Canyon Fuel Company, LLC
SUFCO Mine
397 South 800 West
Salina, UT 84654
(435) 286-4880 Fax: (435) 286-4499

Re: Minor Modification M&RP Permit Amendment, Abandoned Mining Equipment 2LPE,
Canyon Fuel Company, LLC, SUFCO Mine C/041/002

Title: Abandoned Mining Equipment 2LPE

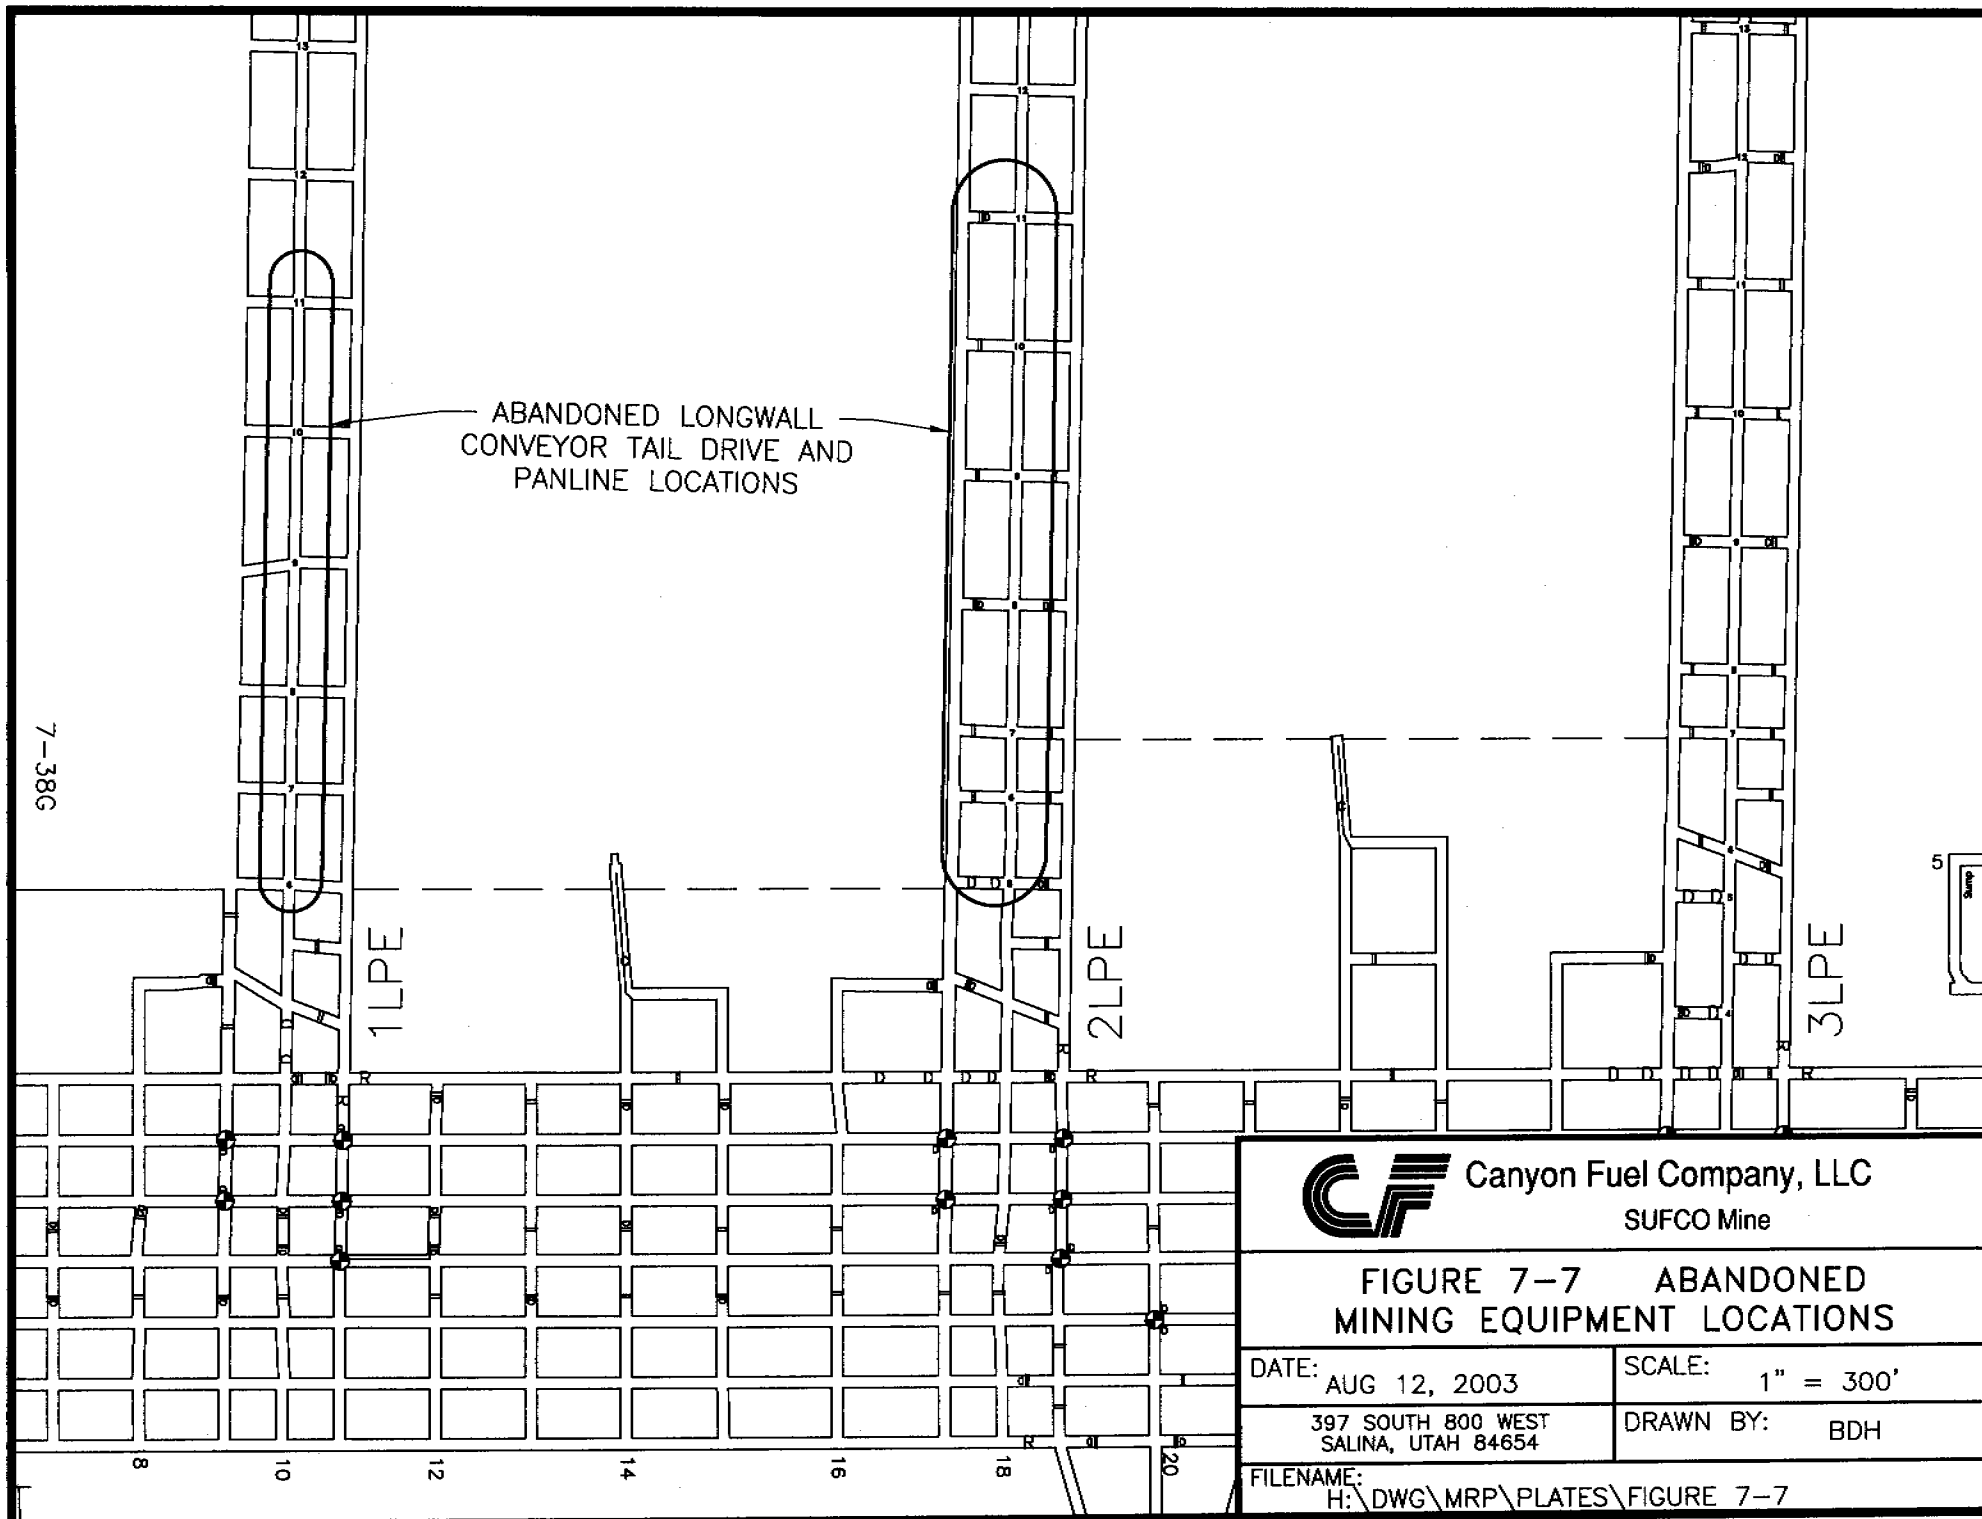
In an effort to reduce the risk to personal safety of our miners SUFCO is submitting this plan to abandon the 2LPE longwall mining conveyor tail drive and panline in the 1LPE and 2LPE gate roads. See attached map Figure 7-7, "Abandoned Mining Equipment Locations." During a longwall move the panline needs to be removed quickly so that the longwall shields can be removed and the area supported before the roof falls in as each shield is dragged to the headgate. This requires that the panline sections be moved a short distance to speed up the removal process. To haul the panline sections out of the mine requires them to be reloaded and hauled ten miles out of the mine with large heavy equipment. Operating and working around heavy equipment in the confined spaces of the mine entrees has been the largest cause of major injuries and has resulted in two fatalities at the SUFCO mine. There is more risk of personal injury to the miners handling and hauling these panline sections out of the mine with heavy equipment in confined spaces than any risk to environmental harm by leaving the equipment in sealed areas in the mine. Hauling the conveyor tail drive and panline outside would create an unnecessary risk to the workers.

Periodically due to difficult recovery conditions or roof collapse, mining equipment is abandoned underground. Abandoned mining equipment locations are shown on Figure 7-7. Prior to leaving equipment underground, lubricating and hydraulic fluids are removed to the extent possible. Since the equipment is steel and not too different compositionally from the roof support throughout the mine, contamination to ground water from abandoned equipment will cause minimal, if any, disturbance to the hydrologic balance within the permit and adjacent areas and is not expected to cause material damage outside the permit area. Assuming the mine were to flood and the abandoned equipment were to be covered with water, several probable results and impacts can be evaluated:
